Phase 1 School - Lindfield Learning Village, Eton Road, Lindfield

Appendix 2 - Response to Submissions (2017)

Appendix 3 – Response to Submissions (2018)

Image 02: External APZs which require works

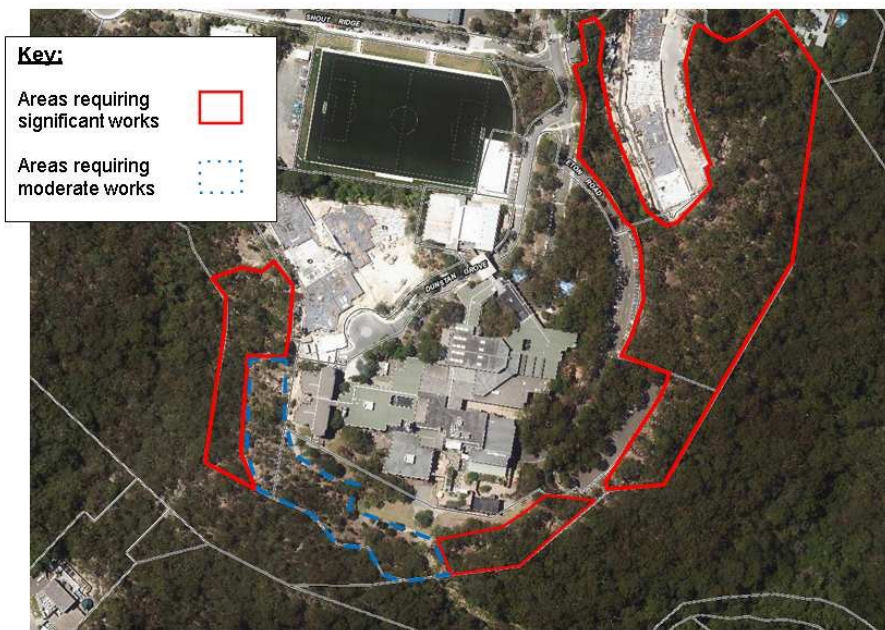
1.6 Significant vegetation removal / management is required to create the Asset Protection Zones onsite which has not been reflected in the EIS or accompanying Biodiversity Assessment Report;

RESPONSE: Addressed - refer to 1.5 above and supporting Bushfire Assessment Report prepared by Blackash regarding proposed vegetation management. All supporting planning approval documents should be amended to reflect required APZs.
